- 5. Right-of-Way Vacation; KPB File 2023-026V
Orion / Canyon Creek Trust
Request: Vacates entire north portion of Waterman Road
dedicated on Skipper's View, Plat HM 81-32
Fritz Creek Area / Kachemak APC**

**ITEM 5 - RIGHT OF WAY VACATION
 VACATE APPROXIMATELY 425 FEET OF THE NORTHERN PORTION OF WATERMAN ROAD AS
 DEDICATED BY SKIPPER’S VIEW, PLAT HM 81-32**

KPB File No.	2023-026V
Planning Commission Meeting:	April 10, 2023
Applicant / Owner:	The Canyon Creek Trust of Homer, Alaska
Surveyor:	Tom Latimer / Orion Surveys
General Location:	Waterman Road, Mile 5 of East End Road, Fritz Creek, Kachemak Bay Advisory Planning Commission
Legal Description:	Waterman Road, Skipper’s View, Plat HM 81-32, Township 6 South, Range 13 West, Section 1

STAFF REPORT

**SKIPPER'S VIEW
2023 ADDITION**

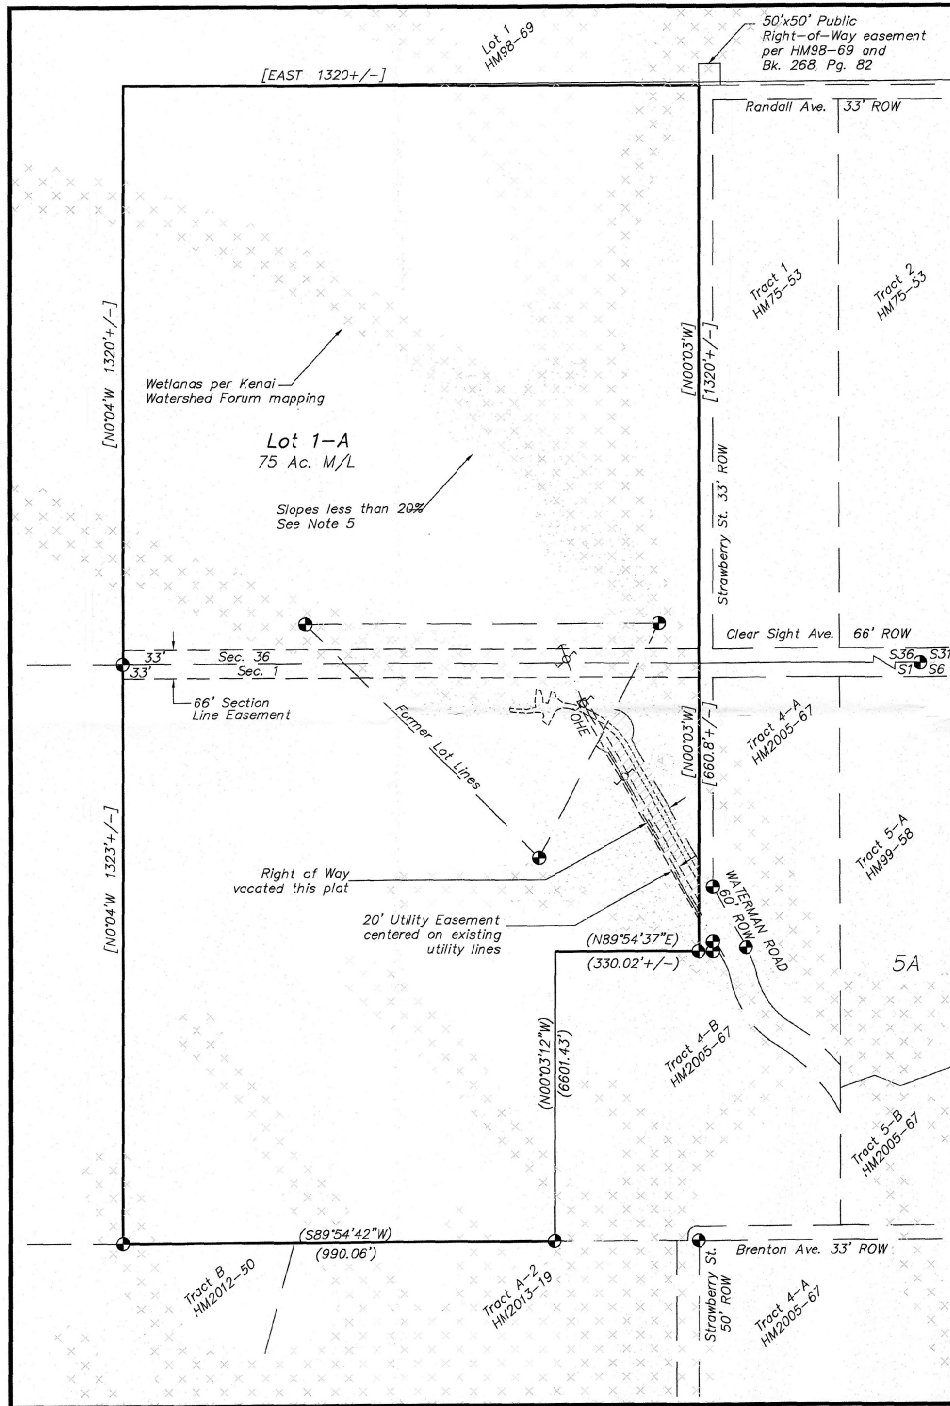
Site Investigation: The right-of-way proposed for vacation is constructed and used to access improvements on Lot 1. The right-of-way is not maintained. It appears that there are areas within the dedication where the slope exceeds 10 percent. Lot 1 and Lot 2 have limited areas not affected by steep terrain. Some of the areas of Lot 2 that have slopes that are not as steep are not accessible due to the current lot configurations.

Skipper’s View, HM 81-32, was a subdivision of aliquot lands. The 75 acre parcel created Lot 2, a 69.5 acre lot, and Lot 1, a 5 acre lot. The design of Lot 1 is unusual as it is a triangle with section line easement that intersect the lot. The placement of Lot 1 was over the best terrain found within in the subdivision. Steep slopes are throughout with limited use. The dedication was to comply with code and provide access to a dedicated street to Lot 1. Looking at older aerial photos it appears the area dedicated was already in use for access to the improvements that are located on Lot 1.

There are steep slopes throughout the subdivision. Some are within Lot 1 but most of the steep terrain is within Lot 2. There are some areas with slopes that are not as steep. Some of those may be accessed from the right-of-way but others are on the other side of Lot 1 and can only be accessed through Lot 1 or by section line easements. The section line easement along the east with a partial dedication for Strawberry Street is subject to very steep slopes and the ability for this to be used for access is minimal.

The parent plat did not grant utility easements adjacent to the right-of-way. An existing powerline was in place that provided service to Lot 1. This powerline appears to be within a portion of the dedication. Per Skipper's View, HM 81-32, the powerline is center of a 20 foot utility easement. The existing easement will remain in place on the replat of the property.

1. The right-of-way or public easement to be vacated is being used;
Staff comments: The right-of-way is currently being used as a driveway to improvements on Lot 1.

2. A road is impossible or impractical to construct, and alternative access has been provided;
Staff comments: Road is constructed as a driveway. The terrain does not comply with KPB Code for maintained roads and would require work to be entered into the KPB maintenance program. The two lots using the road will be combined and share the driveway. All other lots appear to have some form of access.

3. The surrounding area is fully developed and all planned or needed rights-of-way and utilities are constructed;
Staff comments: There are numerous large acreage lots in the area but due to terrain will have limited access. It appears most lots in the general area have some form of access but all may not be feasible. The design of this road only benefits two lots that are to be combined.

5. The proposed vacation would limit opportunities for interconnectivity with adjacent parcels, whether developed or undeveloped;
Staff comments: Only benefits two lots. Ends as a cul-de-sac and due to terrain limited ability to be dedicated any further.

6. Other public access, other than general road use, exist or are feasible for the right-of-way;
Staff comments:
 7. All existing and future utility requirements are met. Rights-of-way which are utilized by a utility, or which logically would be required by a utility, shall not be vacated, unless it can be demonstrated that equal or superior access is or will be available. Where an easement would satisfactorily serve the utility interests, and no other public need for the right-of-way exists, the commission may approve the vacation and require that a utility easement be granted in place of the right-of-way.
Staff comments: An easement is in place over the existing powerlines and will be carried over. Any easements requested by the utility providers shall be considered.

8. Any other factors that are relevant to the vacation application or the area proposed to be vacated.
Staff comments: The vacation will place the driveway back onto private property and it currently only provides access to improvements that are in the middle of 75 acres.

Based on consideration of the merits as per KPB 20.65.050(D) as outlined by Staff comments, Staff recommends **APPROVAL** as petitioned, subject to:

1. Consent by KPB Assembly.
 2. Compliance with the requirements for preliminary plats per Chapter 20 of the KPB Code.
 3. Grant utility easements requested by the utility providers.
 4. Submittal of a final plat within a timeframe such that the plat can be recorded within one year of vacation consent (KPB 20.70.130).
-
